## First Revision No. 1-NFPA 99-2015 [ Global Input ]

Revise/Reorganize Chapter 6 as shown in the word doc.

Figure A.5.1.3.5.11 Elements of an Oxygen Concentrator Supply Source

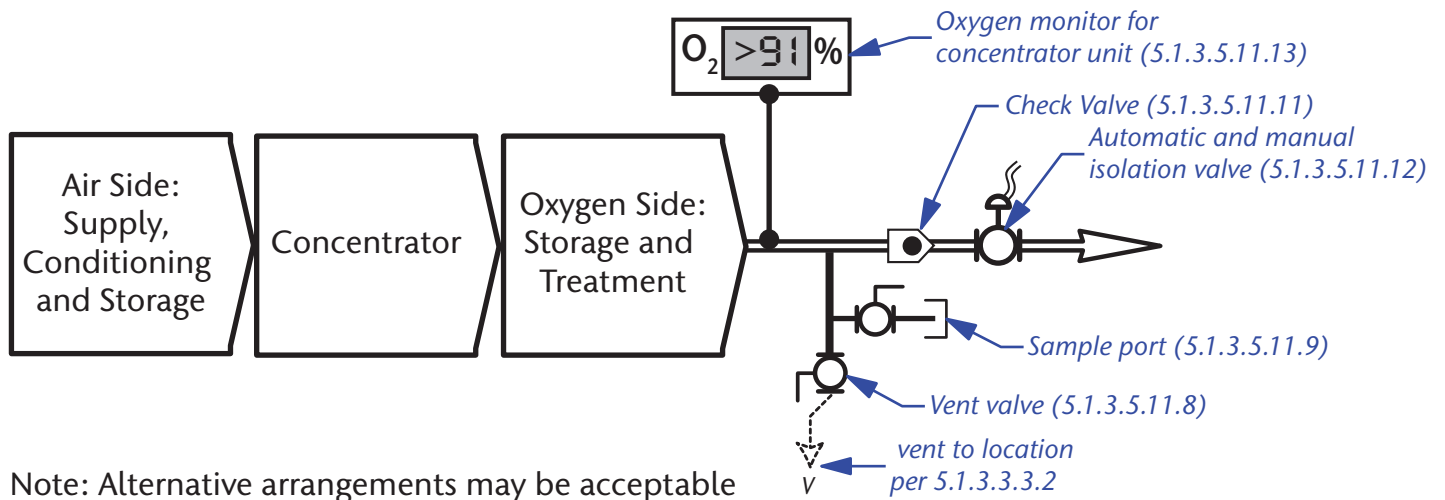
<b><u>File Name</u></b>	<b><u>Description</u></b>
PI_150_FR.pdf	Figure modified from the original submittal
FR_609_Annex_Material.docx	Annex material. See PDF for the figure

See Figure A.5.1.3.5.11

#### Figure 10.3.6.3 Test Circuit for Measuring Leakage Current Between Patient Leads and Ground — Nonisolated.

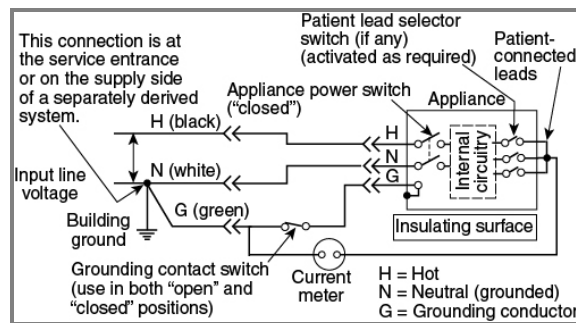
The leakage current between all patient leads connected together and ground shall be measured with the ground switch open and with the ground switch closed.

An acceptable test configuration shall be as illustrated in [Figure 10.3.6.2](#) [Figure 10.3.6.3](#).
